Report: PUNCH LIST
Function: Test, Adjust, & Balance
Date: 02/04/2026
Completed By: National TAB

PROJECT
02-02-26 CULVERS - CHARLOTTE, NC

Project: 02-02-26 CULVERS - CHARLOTTE, NC

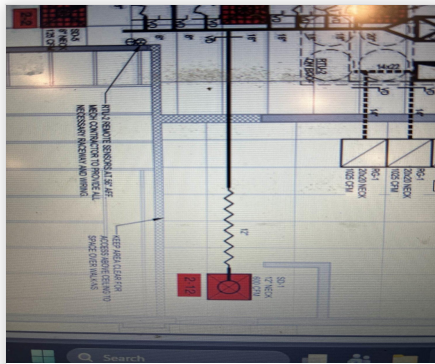
Issue Name : Damper inaccessible
Description : Damper inaccessible, supply drop is laying on ceiling pad, unable moved. diffuser is taking to the air from neighboring diffusers.
Created By : National TAB **Assigned To :** National TAB - Dan Hertenstein
Status : Open
Priority : Medium **Asset Tag :** SGRD10
Originated Date : 02/05/2026 - Jearod Ferrette - National TAB

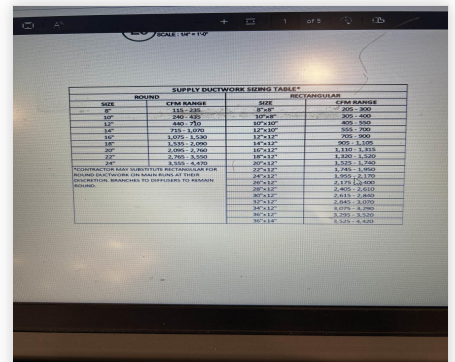
Issue Name : RTU-2 ductwork undersized
Description : RTU 2 is currently at 88% of design total flow. The ductwork from the unit was installed horizontally, this restricts the unit. On the MSET rooftop drawings refers to a note (M101) about proper ductwork size. Currently the supply ductwork 25x14 and also insulated inside. Supply pressure is at 1.50", the unit was at max amps 26.9a @61.5hz.

- **02/04/2026 National TAB - Jearod Ferrette**
 - The unit was slowed down by 2hz, to bring down the amps. Per the mechanical there is an email chain from Captive Air. The engineers wanted the unit to be ducted horizontally. This unit will be proportionally balance.

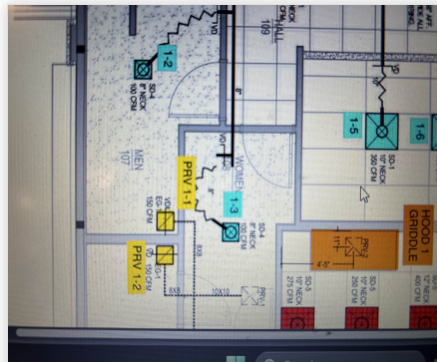
Issue Name : Women's RR damper inaccessible
Description : Women's restroom, damper inaccessible above hard ceiling.
Created By : National TAB **Assigned To :** National TAB - Dan Hertenstein
Status : Open
Priority : Medium **Asset Tag :** SGRD3
Originated Date : 02/05/2026 - Jearod Ferrette - National TAB
